GEORGIA POWER COMPANY
OGLETHORPE POWER CORPORATION
MUNICIPAL ELECTRIC AUTHORITY OF GEORGIA
CITY OF DALTON, GEORGIA
DOCKET NO. 50-321
EDWIN I. HATCH NUCLEAR PLANT, UNIT NO. 1
AMENDMENT TO FACILITY OPERATING LICENSE

Amendment No. 126
License No. DPR-57

ATTACHMENT TO LICENSE AMENDMENT NO. 126

SAFETY EVALUATION BY THE OFFICE OF NUCLEAR REACTOR REGULATION
SUPPORTING AMENDMENT NO. 126 TO FACILITY OPERATING LICENSE NO. DPR-57
GEORGIA POWER COMPANY
OGLETHORPE POWER CORPORATION
MUNICIPAL ELECTRIC AUTHORITY OF GEORGIA
CITY OF DALTON, GEORGIA
EDWIN I. HATCH NUCLEAR PLANT, UNIT NO. 1
DOCKET NO. 50-321

Figure 3.6-1. Pressure versus Minimum Temperature for Pressure Tests, Such as Required by ASME Section XI

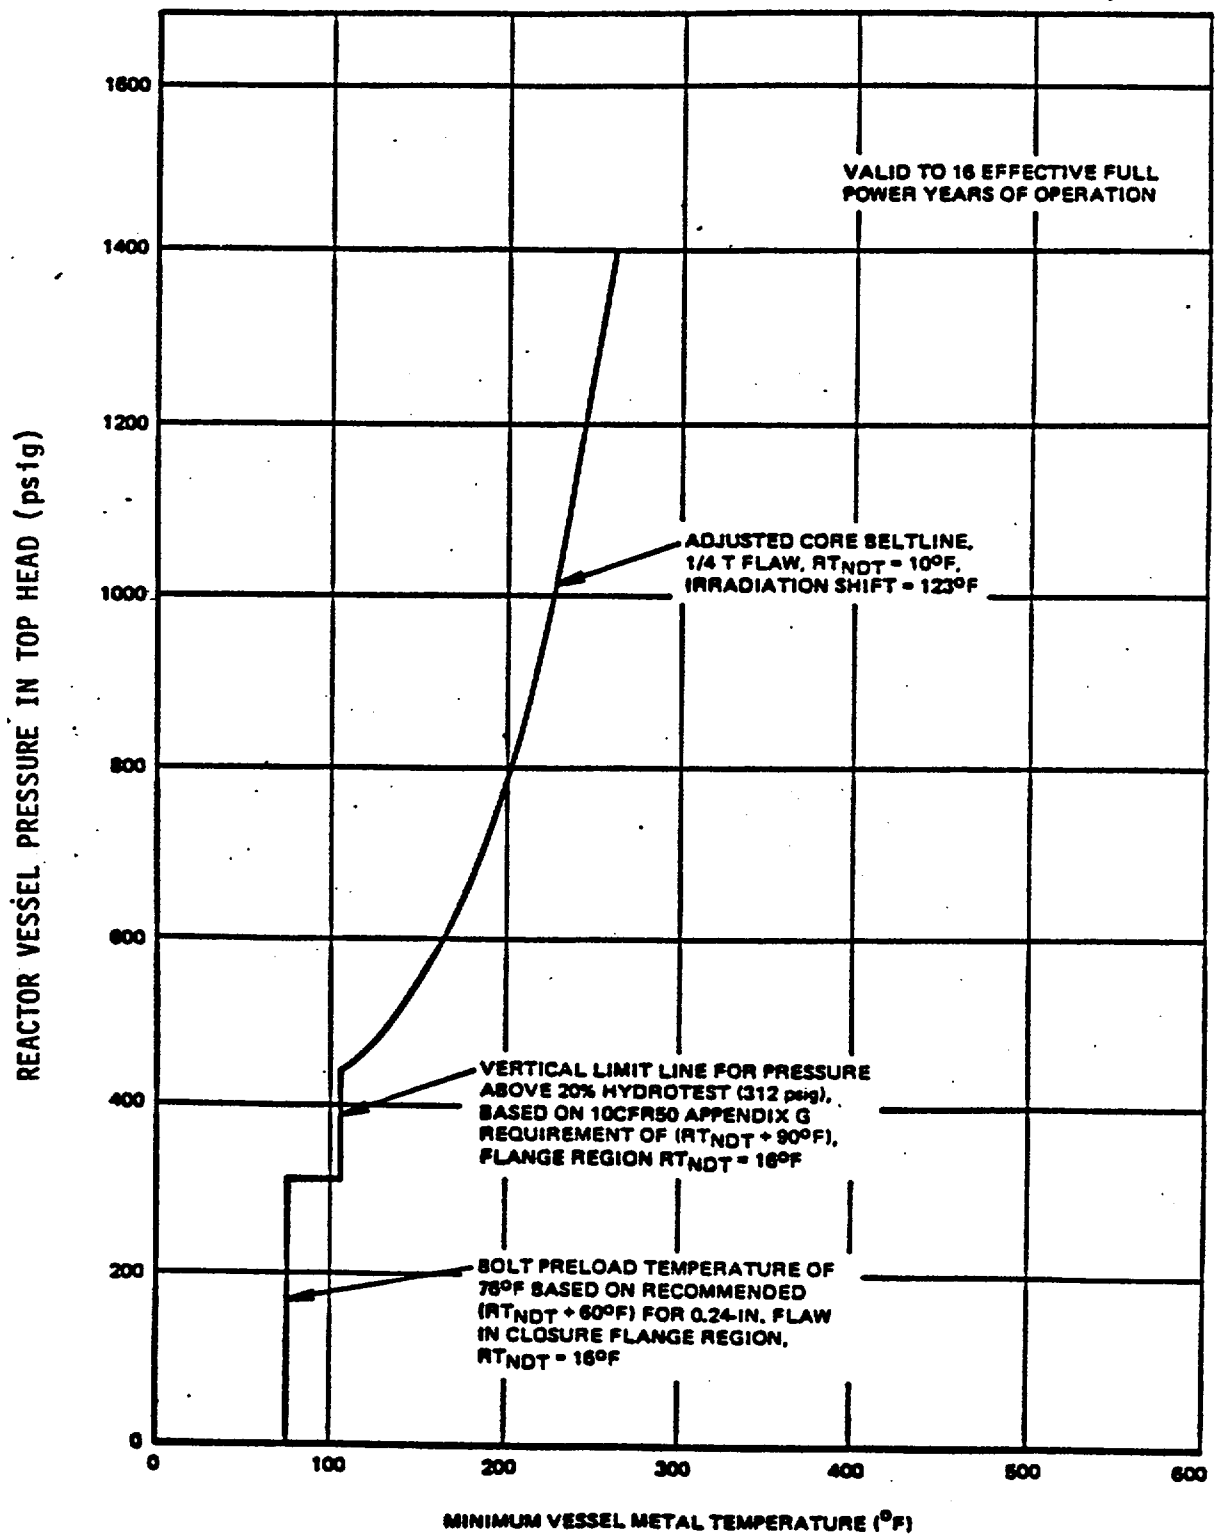
The amendment revises the TSs to change the reactor vessel operating temperature and pressure limits and to make associated editorial changes.

Figure 3.6-1 establishes minimum temperature requirements for leak testing and hydrostatic testing required by the ASME Boiler and Pressure Vessel Code, Section XI.

Test pressures for inservice hydrostatic and leak testing required by the ASME B&PV Code, Section XI, are a function of testing temperature and component material. For the Hatch 1 reactor pressure vessel, the ISI hydrostatic test pressure would be approximately 1.1 times operating pressure, or about 1106 psig, depending on the reactor water temperature. The temperatures for pressures above 440 psig are determined by the RPV core beltline with a shift in RT_{NDT} of 123°F, appropriate for operation up to 16 effective full power years (EFPY).

We have reviewed Figure 3.6-1, "Pressure Versus Minimum Temperature for Pressure Tests, Such as Required by ASME Section XI," Figure 3.6-2, "Pressure Versus Minimum Temperature for Non-Nuclear Heatup/Cooldown and Low Power Physics Tests," and Figure 3.6-3, "Pressure Versus Minimum Temperature for Core Critical Operation (Includes 40°F Margin Required by 10 CFR 50, Appendix G) of NEDC-30997. We conclude that these curves are conservative, preserve a margin of safety for Hatch Unit 1 reactor vessel test and operation and are acceptable. Although we find the proposed curves acceptable in this case, we do not agree that the methodology used in conducting the analysis would be applicable for general use. Therefore, our acceptance of these specific limit curves does not constitute generic approval of the methodology.

1. The reactor vessel shell temperatures during inservice hydrostatic or leak testing shall be at or above the temperatures shown on the curve of Figure 3.6-1.

Figure 3.6-2. Pressure versus Minimum Temperature for Non-Nuclear Heatup/Cooldown and Low Power Physics Tests

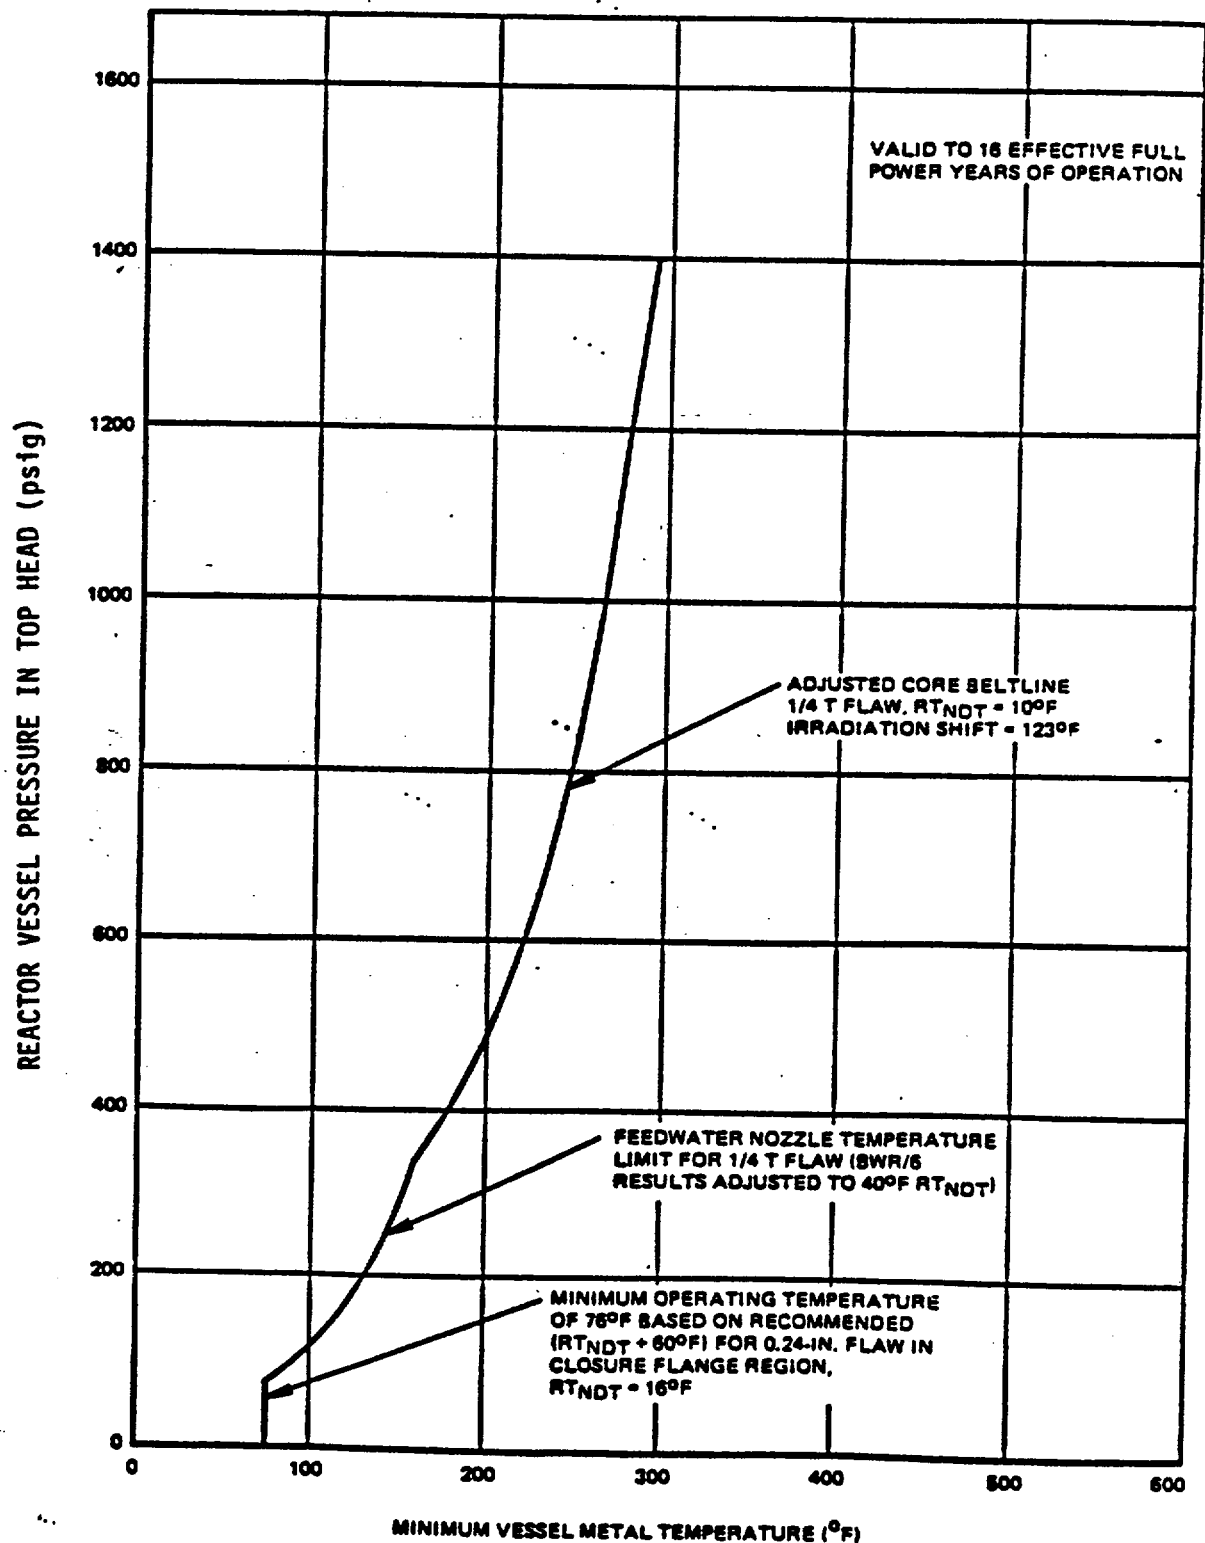
Figure 3.6-2 provides appropriate limitations for plant heatup and cooldown when the reactor is not critical. Figure 3.6-2 is also applicable to low power physics tests. These curves assume heatup and cooldown rates up to 100°F per hour. Temperatures for pressures above 300 psig represent the limits of the RPV core beltline with a shift in RT_{NDT} of 123°F, appropriate for 16 EFPY of operation.

2. During heatup by non-nuclear means, cooldown following nuclear shutdown or low level physics tests, the reactor vessel shell and fluid temperatures of Specification 4.6.A. shall be at or above the temperatures shown on the curve of Figure 3.6-2.
3. During all operation with a critical core, other than for low level physics tests, the reactor vessel shell and fluid temperatures of Specification 4.6.A. shall be at or above the temperatures shown on the curve of Figure 3.6-3.

Figure 3.6-3. Pressure versus Minimum Temperature for Core Critical Operation other than Low Power Physics Tests (Includes 40°F Margin Required by 10CFR50 Appendix G)

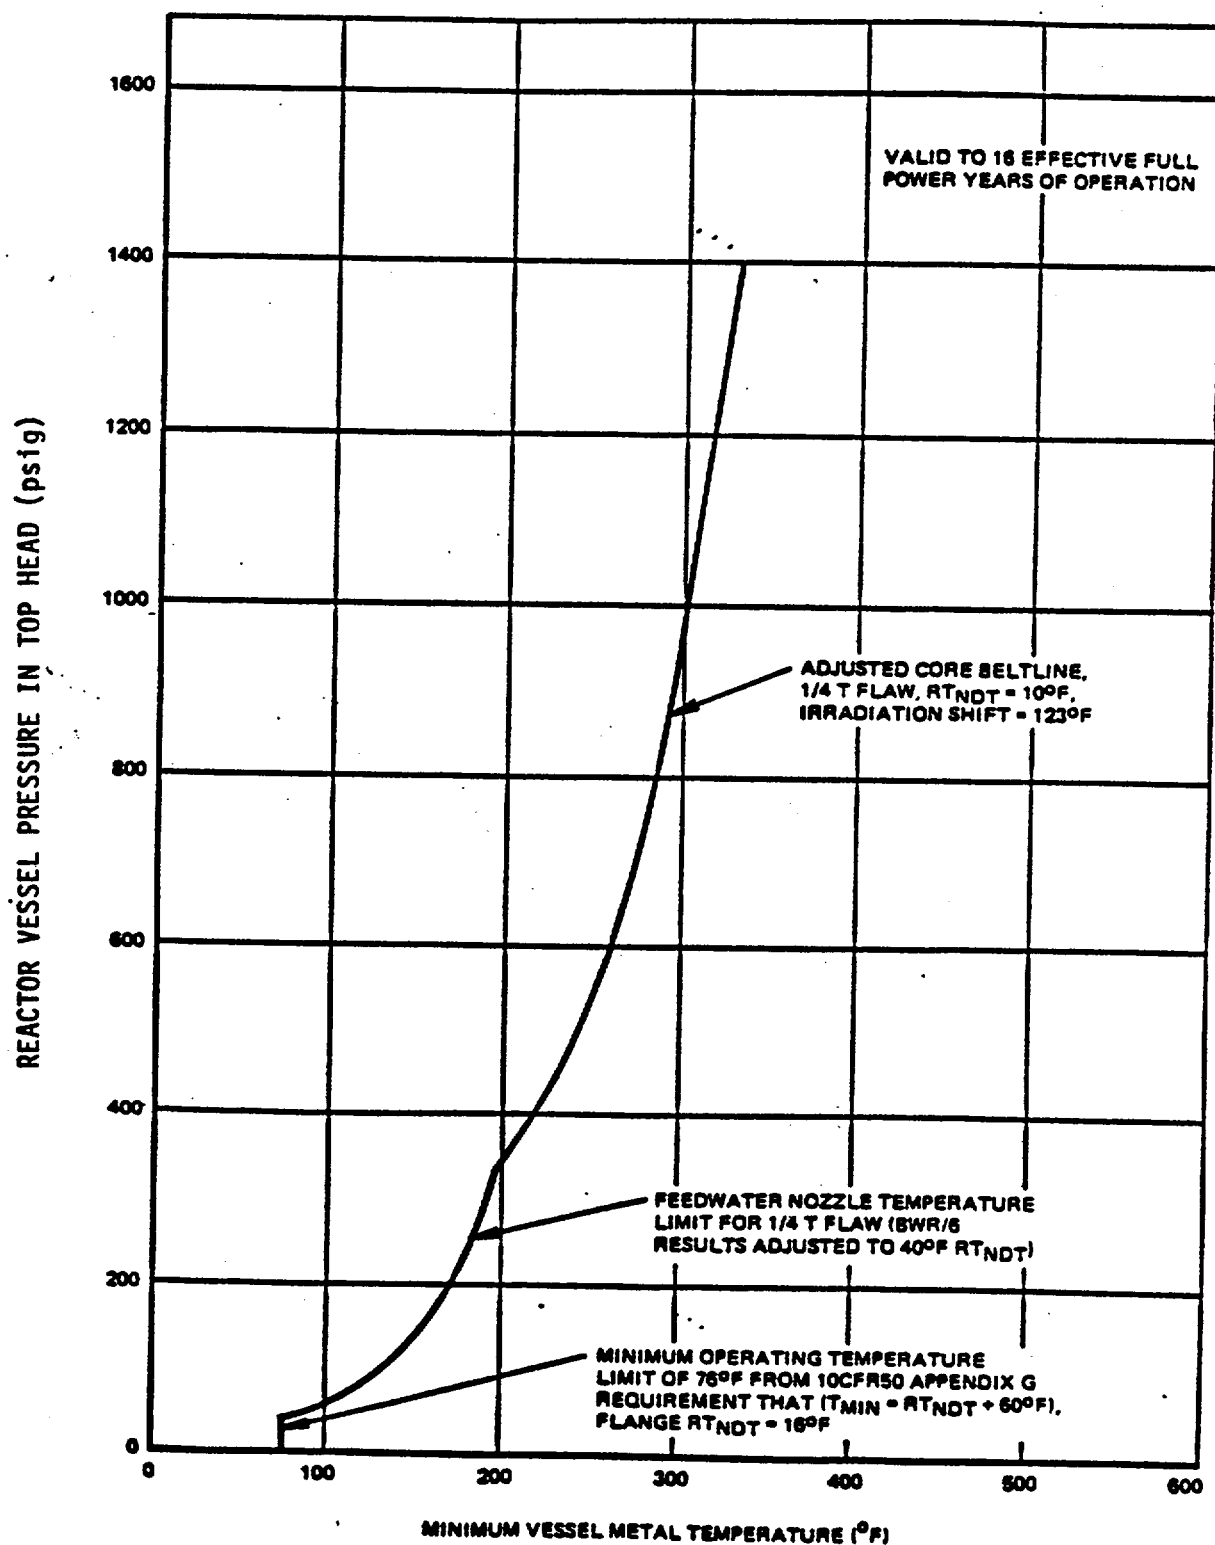
Figure 3.6-3 establishes operating limits when the core is critical. Figure 3.6-3 is not applicable to low power physics tests. These limits include a margin of 40°F as required by 10CFR50 Appendix G. In accordance with the May 1983 revision of 10CFR50 Appendix G, core critical operation may be initiated at temperatures at or above ($RT_{NDT} + 60°F$) of the closure flange region, or 76°F. Temperatures for pressures above 300 psig represent the limits of the RPV core beltline with a RT_{NDT} shift of 123°F, appropriate for 16 EFPY of operation.
